ORDINARY COUNCIL MEETING

Part 1 - Item 9.3 - Attachments 1-11

9.3	Planning Proposal - 160 Burwood Road, Concord (the Bushells site)	
	Attachment 1 Planning Proposal - 160 Burwood Rd Concord (as exhibited).....	5
	Attachment 2 LEP maps (revised post-exhibition)	117
	Attachment 3 Report on submissions	122
	Attachment 4 Urban Design Review by Council	185
	Attachment 5 DCP-03_Part-B-General-Controls	282
	Attachment 6 DCP-12_Part-K-Special-Precincts_Former-Bushells-Factory	396
	Attachment 7 Survey	425
	Attachment 8 Urban Design Report.....	436
	Attachment 9 Concept Plan, Analysis and SEPP 65 Certification	516
	Attachment 10 Landscape Master Plan	535
	Attachment 11 Public Domain Plan	536

AMENDED PLANNING PROPOSAL (PP2018/0004)

Figure 23 Proposed elevations (BVN 2022, p.7)

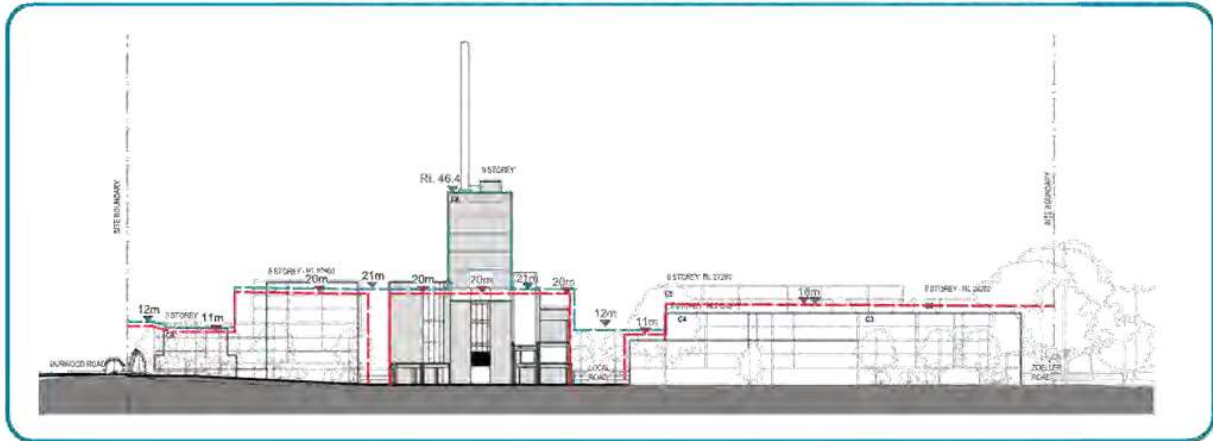
Proposed LEP maximum Height of Building (in blue) and Studio GL's recommended maximum building heights- Aug 2022 (in red)

Figure 54 Movement and Access Diagram (Hatch Roberts Day 2022, p50)

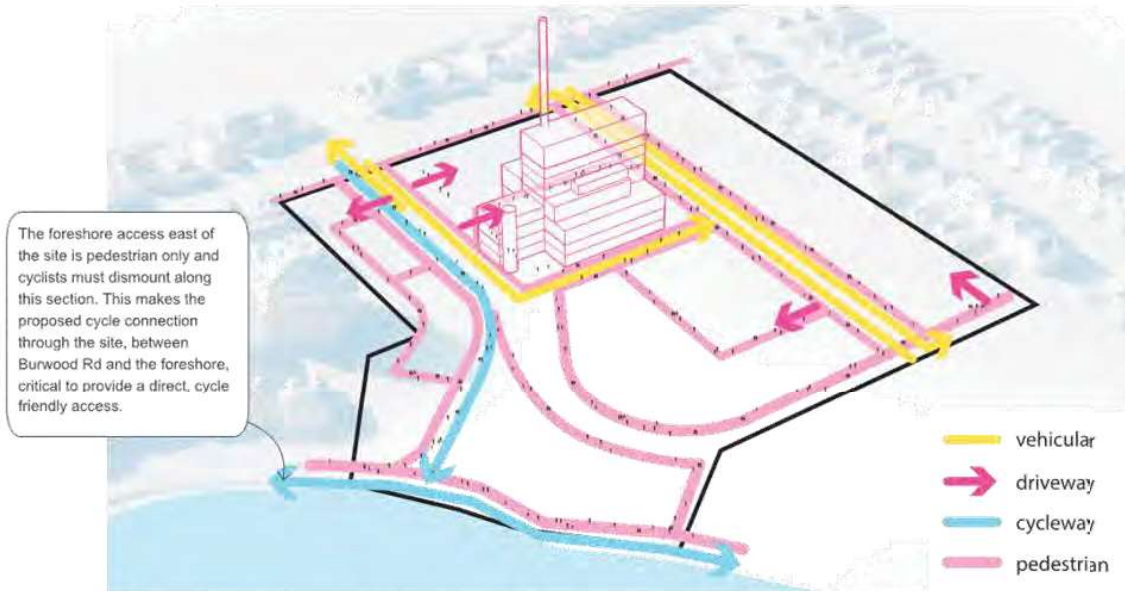
To reduce the impact on Zoeller Street, it is recommended that the primary access to Blocks 1 and 5 the site is provided from inside the site and accessed off one of the new roads linking to Burwood Road. Any Zoeller Street connection should be designed as a slow speed secondary link with the width of the road narrowed. Ideally truck movements, especially trucks servicing the retail and light industrial uses should occur off Burwood Road. A pedestrian link with a minimum width of 4.5m will need to be established within the site along the northern boundary to accommodate public access if Zoeller Street can not be extended.

Figure 58 Recommended Foreshore Building Line, annotated, Studio GL, 2022

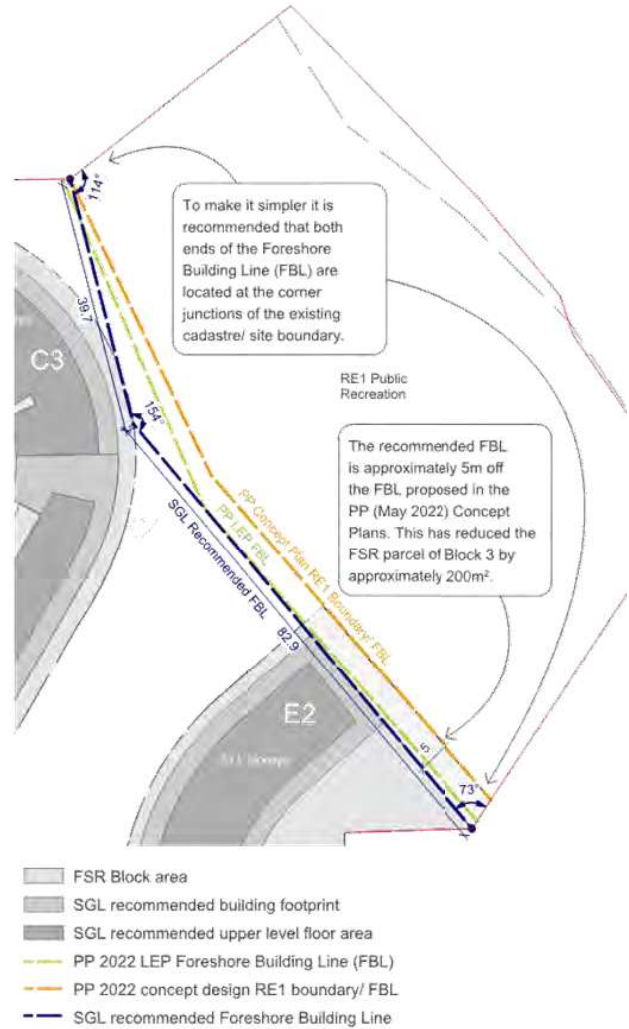
Studio GL also recommends adjusting the proposed Foreshore Building Line so that it clearly defines the proposed maximum building footprint. This modification is shown by the navy line in Figure 58. This will strengthen the planning controls and further ensure no built form occurs beyond the building envelopes proposed in the Concept Plan.

Figure 65 Draft DCP Building Envelope Diagram annotated with Studio GL recommendations where changes are suggested in orange

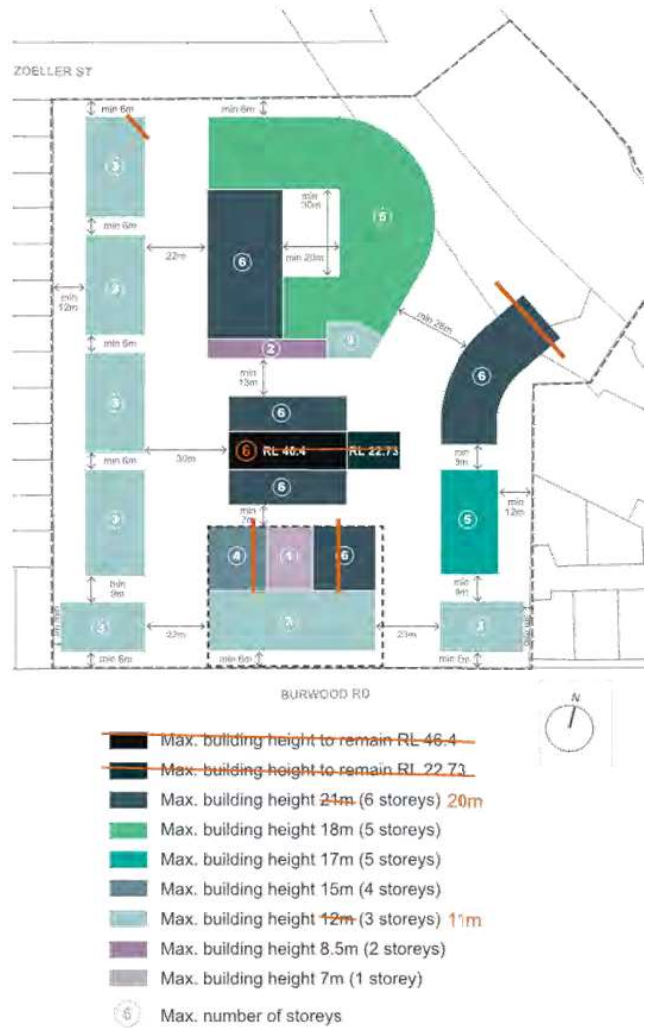
Generally, the minimum setbacks, road reserves and separation distances presented in the draft DCP building envelope diagram are supported and it is recommended that the controls be adopted and reflected in future design development.

Figure 66 Concept Plan elevations (BVN 2022) overlaid with PP (May 2022) LEP maximum Height of Building (in blue) and Studio GL's recommended maximum LEP building heights 2022 (in red)

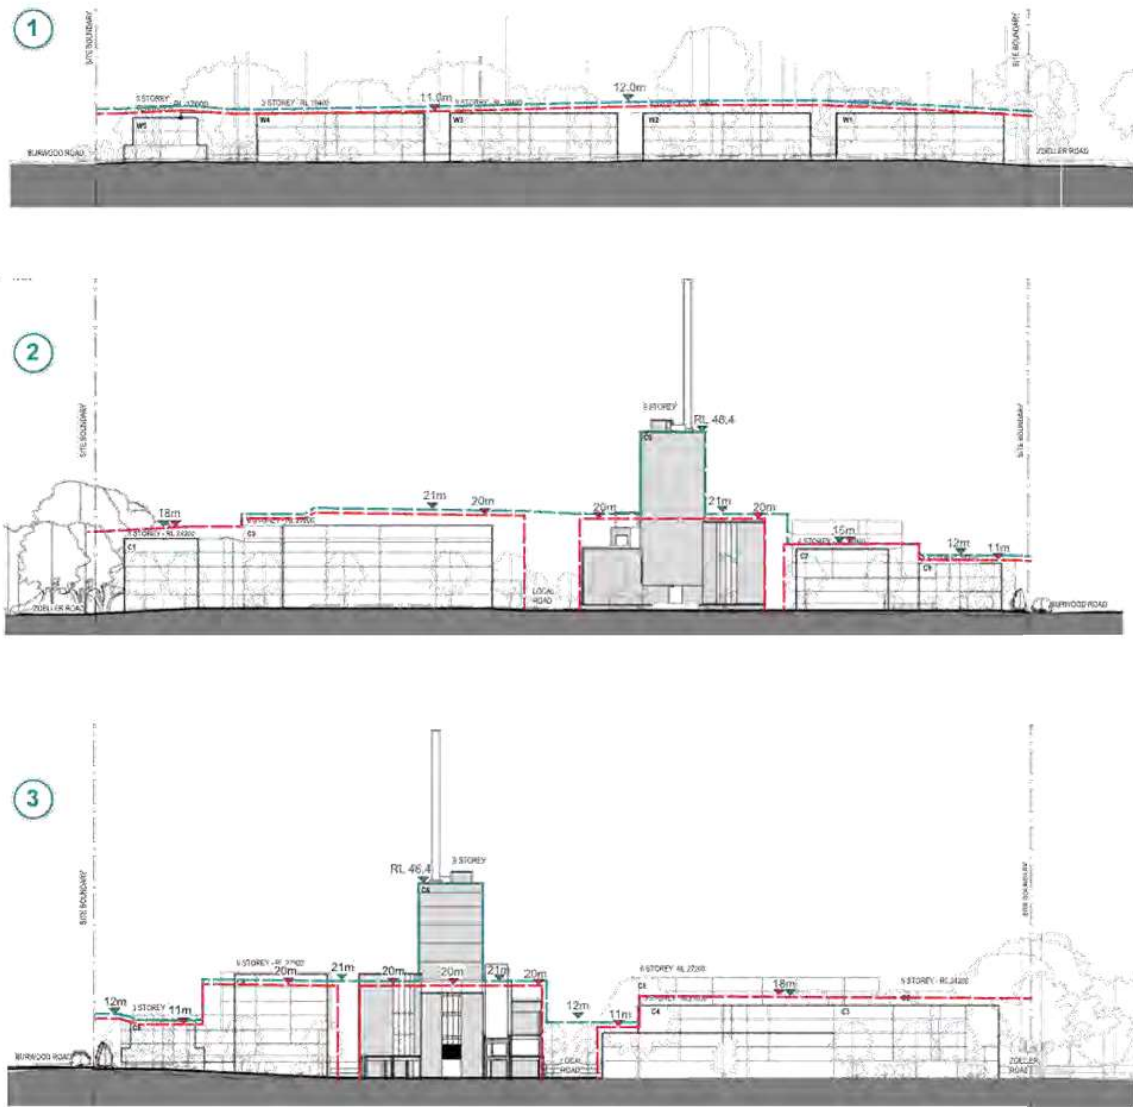
The maximum building heights in the proposed amended LEP map identified in the PP (May 2022) are greater than needed to accommodate the proposed built form and could, potentially, encourage even taller development in the future. To avoid this the following is recommended (as shown in Figure 64):

Figure 71 Draft DCP FSR Block Diagram annotated with Studio GL recommendations where changes are suggested in orange

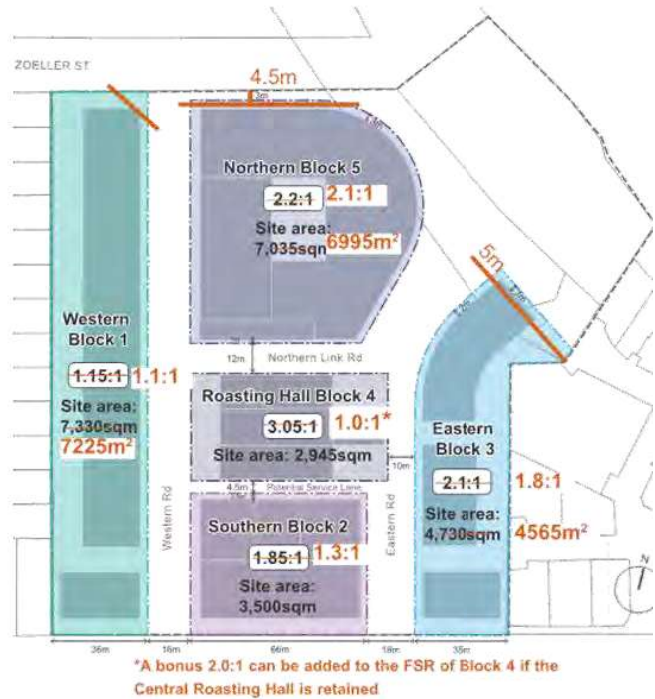
It is recommended that FSR in the CBLEP is identified per block to ensure lower FSRs are located next to the sensitive interfaces with higher FSR for Block 5 and the Central Roasting Hall similar to the diagram shown in Figure 69. These recommendations should also be reflected in the draft DCP FSR Block diagram as suggested in Figure 71.
